Energy Assessment
PA2604238

Springvale BESS

Officer Assessment

Department
of Transport
and Planning

Figure 1: Proposed layout of the BESS; Stage 1 on the left, Stage 2 on the right. Source: Application documents.

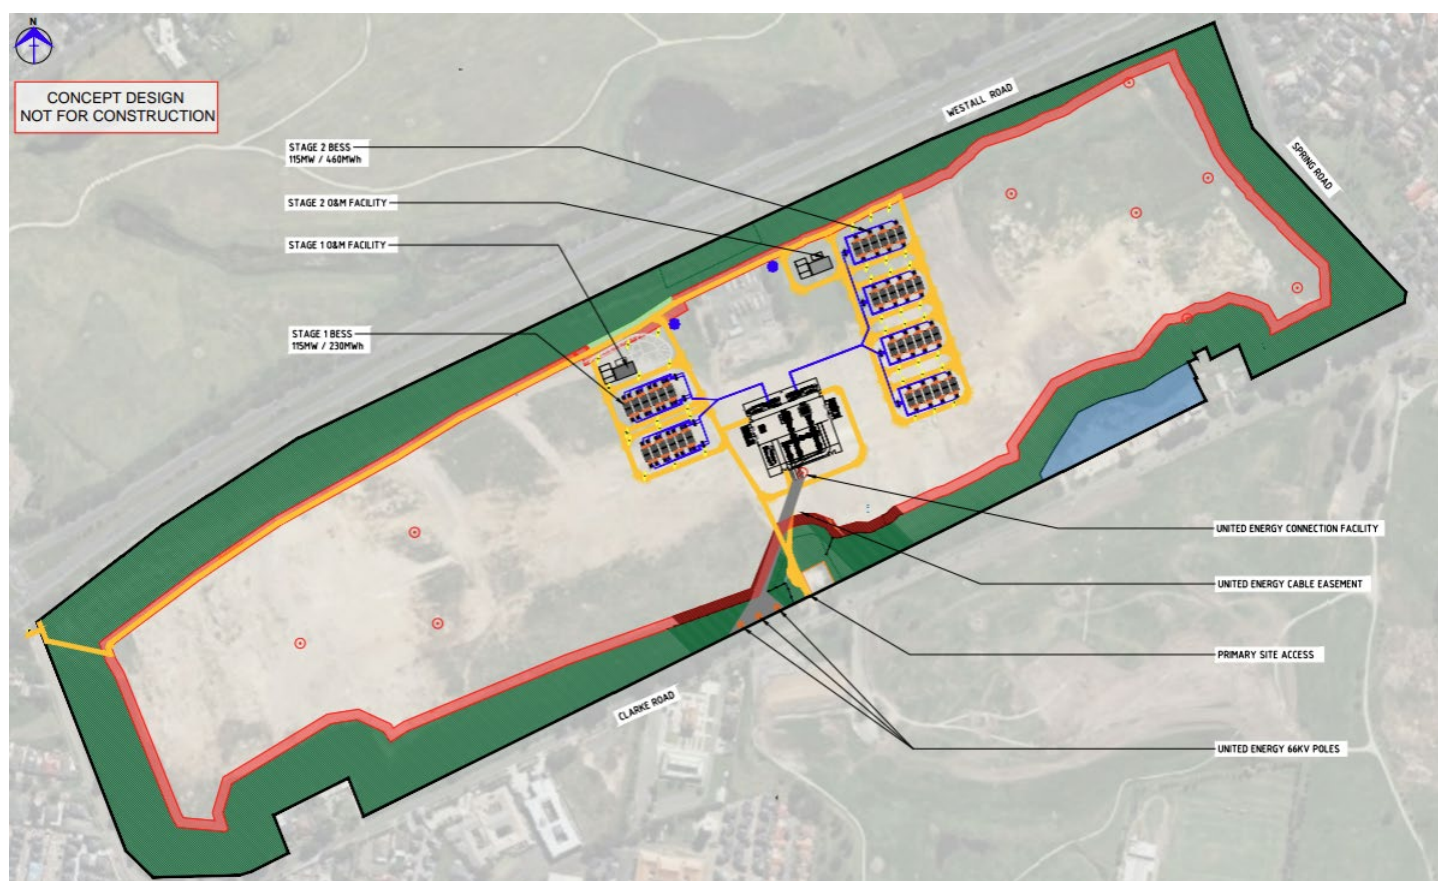
58. A permanent carparking area has been provided to the west of the Stage 1 BESS. There are also internal access roads throughout the site, which will enable vehicles to park elsewhere onsite while undertaking construction and / or maintenance activities as needed.

59. The location and size of the car parking area is considered acceptable subject to conditions being included on any permit issued requiring the specific dimensions of the car parking area to be shown on the plans in accordance with clause 52.06-9.

Figure 8: View towards the site from Spring Road Reserve (VP6).

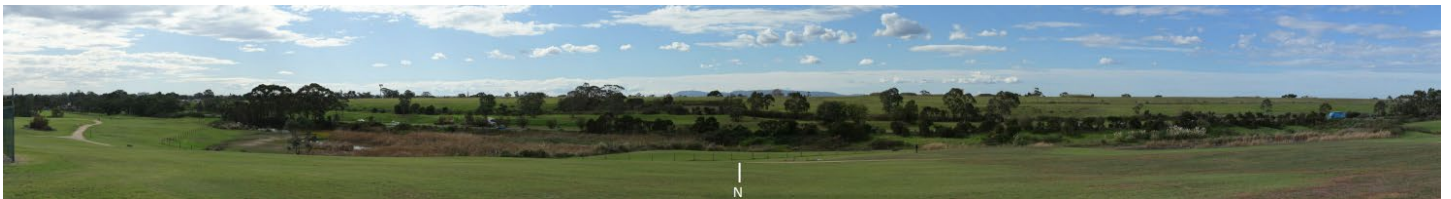
67. The proposed BESS will be visible from centre of the Spring Road Reserve (VP6) and the Spring Valley Park (VP7) as these sites are also elevated former landfills, so it is possible to see 'up and over' the sites rise and to the centre of the land where the BESS is proposed. However, the impact is considered to be low and acceptable given the distance from the BESS units (at least 170m), the low height of the infrastructure and the presence of roadside vegetation on Clarke Road and Westall Road which will assist in tempering views from the reserves.

70. Rather, it is recommended that conditions of any permit issued require the planting of two landscape buffers along the northeast and southwest elevations of the facility (parallel with Westall and Clarke Roads) to temper views from the Spring Road Reserve and Spring Valley Park where the project will be the most visible.
